CALVERT CLIFFS 1 CYCLE 7
TECHNICAL SPECIFICATION CHANGES

TABLE 9-2
EXPLANATIONS FOR CYCLE 7 TECH. SPEC. CHANGES

Figure 3.2-3b

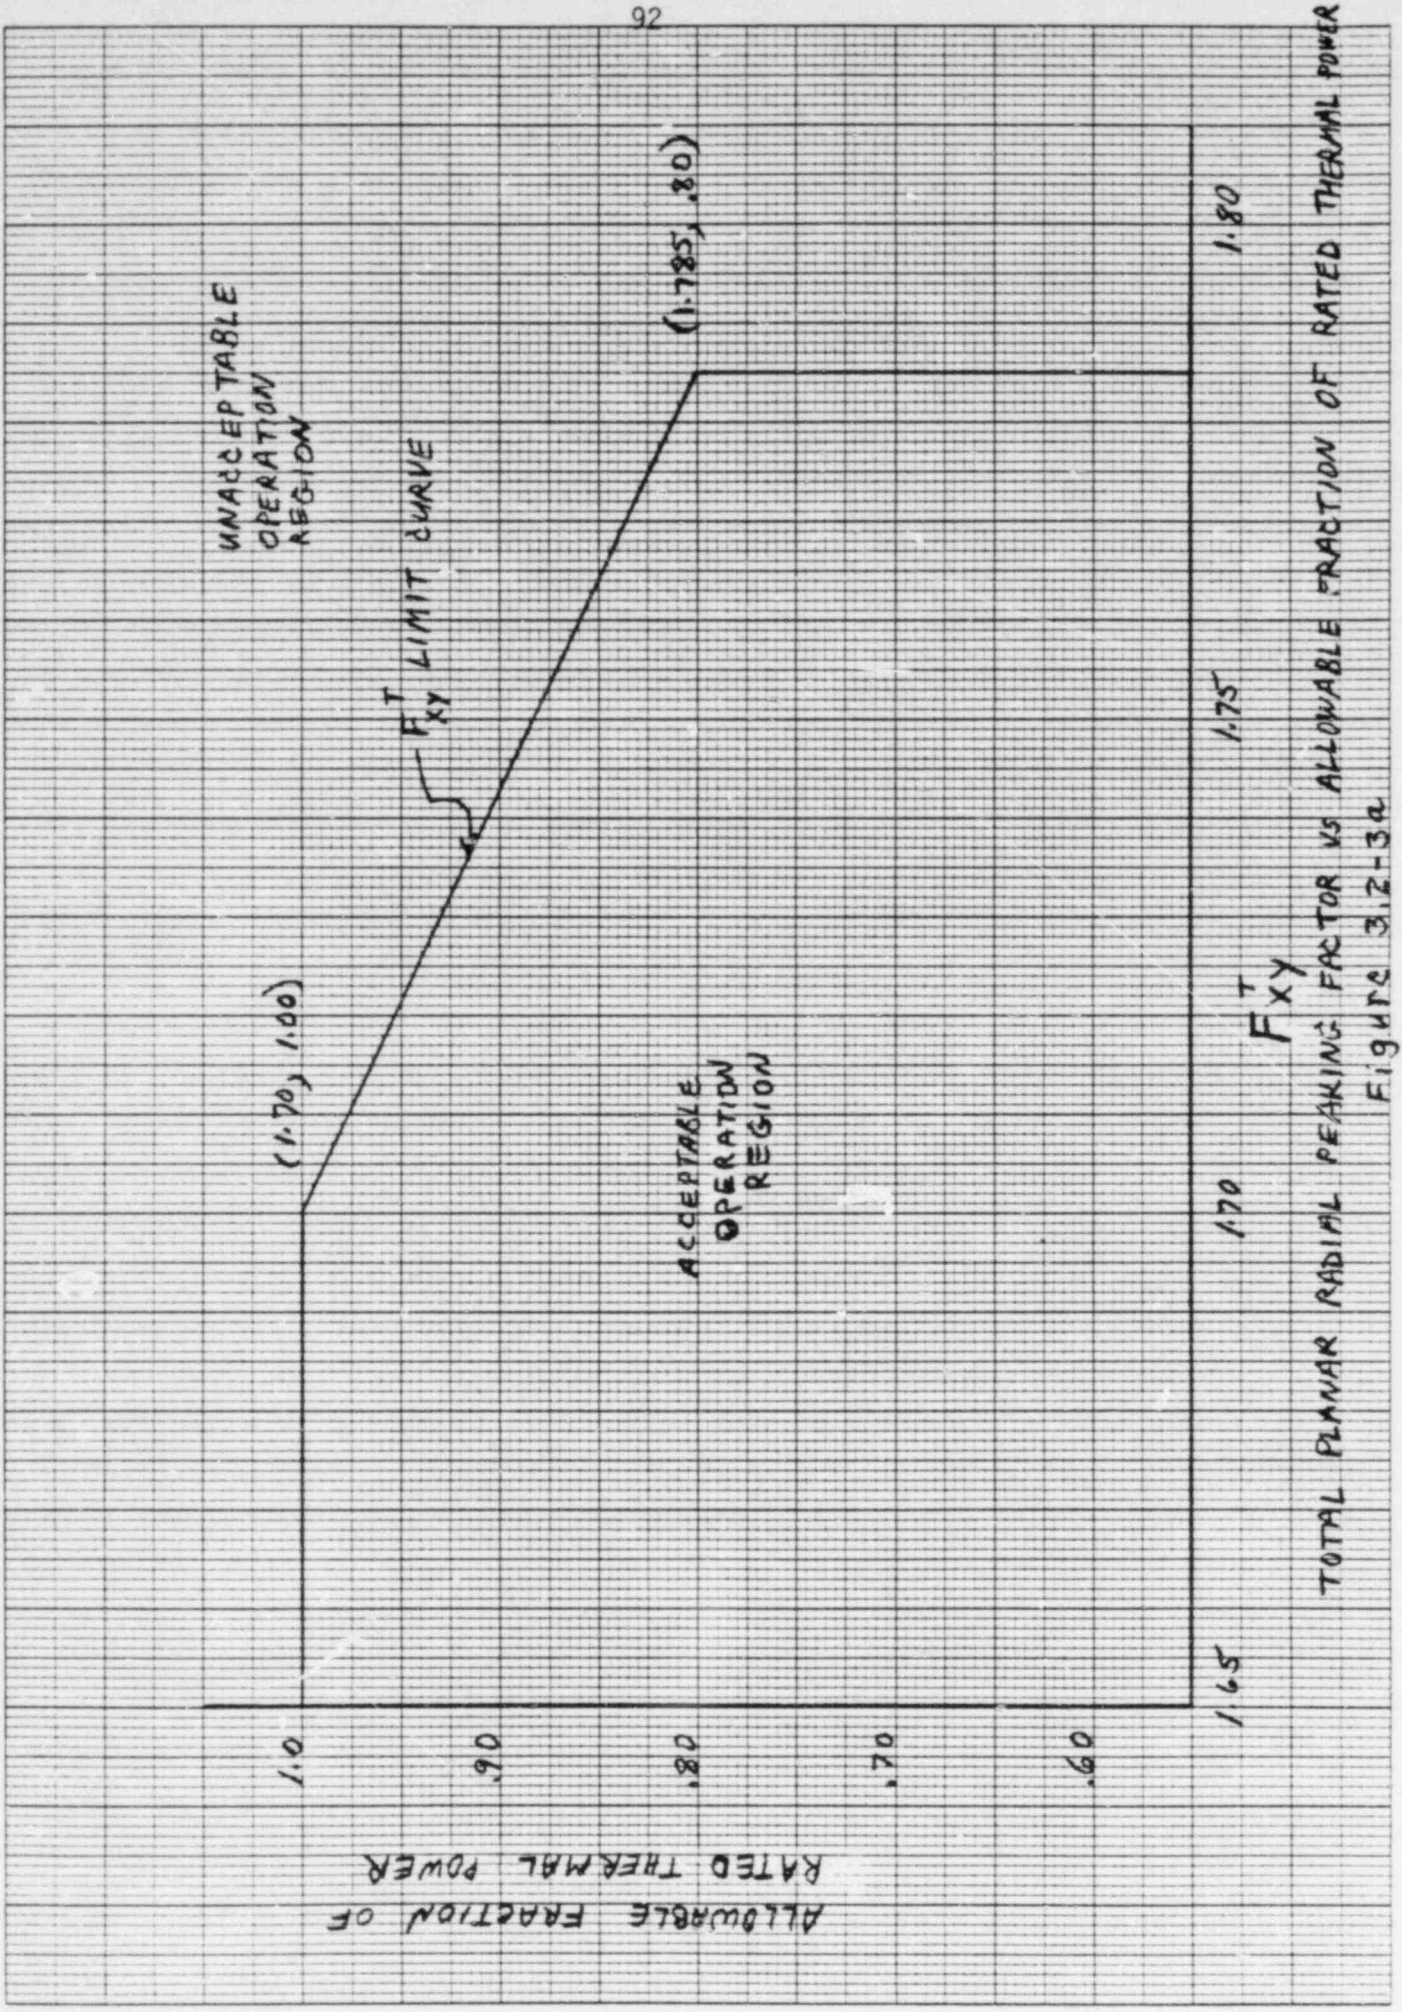
9	Figure 3.2-3b page 3/4 2-4a	Replace Figure 3.2-3b with enclosed Figure 3.2-3b.
10	3.2.2.1 page 3/4 2-6	Change calculated value of F_{xy}^T from 1.65 to 1.70.
11	Figure 3.2-3a page 3/4 2-7a	Replace Figure 3.2-3a with enclosed new Figure 3.2-3a
12	3.2.3 page 3/4 2-9	Change Figure 3.2-3a to Figure 3.2-3c.
13	Figure 3.2-3c page 3/4 2-10a (new)	Insert enclosed new Figure 3.2-3c after page 3/4 2-10.
14	Table 3.2-1 page 3/4 2-14	Change minimum pressurizer pressure from 2225 psia to 2200 psia.

8	4.1.1.4.2	The surveillance requirements on MTC are being modified to allow the use of MTC determinations made during power ascension startup measurements for the purpose of satisfying surveillance requirements. This change is consistent with the objective of assuring that the most positive MTC at power conditions, which occurs at the highest boron concentration, meets Tech. Spec. 3.1.1.4.b.
9	Figure 3.2-3b	Figure 3.2-3b is being revised due to the separation of the allowable F_{xy}^T and F_{xy}^T curves into separate figures (see Change Nos. 11, 12 and 13).

FIGURE 3.2-3a

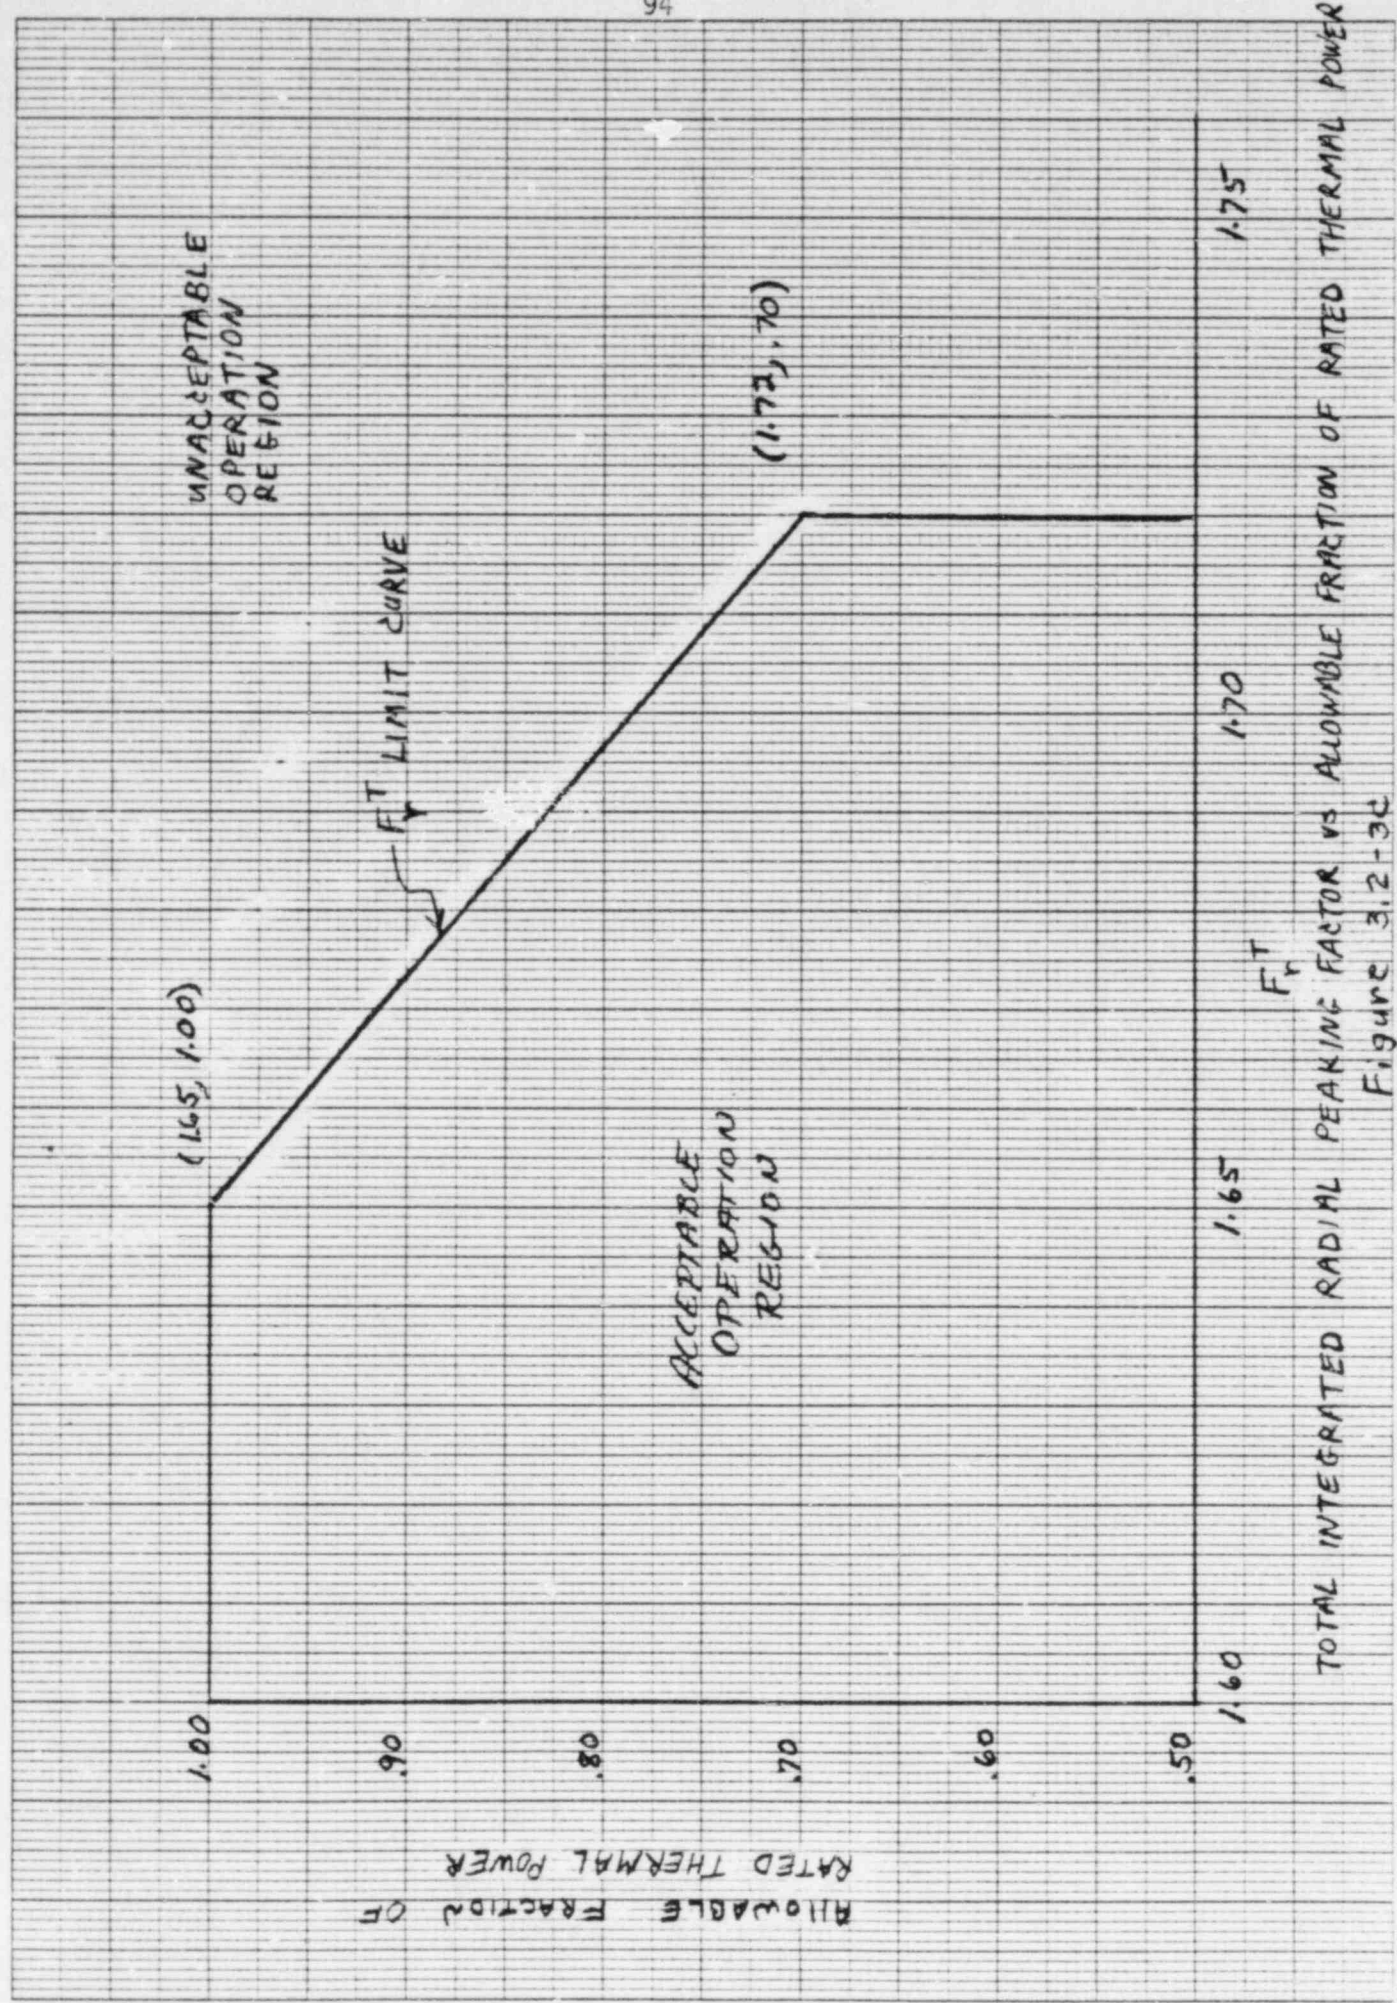
<u>Changes</u>	<u>Tech. Spec. #</u>	<u>Explanation</u>
10	3.2.2.1	The planar radial peaking factor, F_{xy}^T , is being raised for Cycle 7 to increase operating margins and flexibility.
11	Figure 3.2-3a	The planar radial peaking factor, F_{xy}^T , is being raised for Cycle 7 to increase operating margins and flexibility and the F_{xy}^T curve is being separated from the F_r^T curve to accommodate different F_{xy}^T and F_r^T values.
12	3.2.3	Figure 3.2-3c is being added to facilitate the separation of the F_{xy}^T and F_r^T curves to accommodate different F_{xy}^T and F_r^T values.
13	Figure 3.2-3c	See Change No. 12.
14	Table 3.2-1	The minimum steady state pressurizer pressure has been lowered to increase operating flexibility.
15	Table 3.3-1	See Change No. 2.
16	Table 3.3-3	The description of the Engineered Safety Feature Actuation System Instrumentation for Auxiliary Feedwater is being revised and augmented to reflect the implementation of the Safety Grade Auxiliary Feedwater Actuation System.
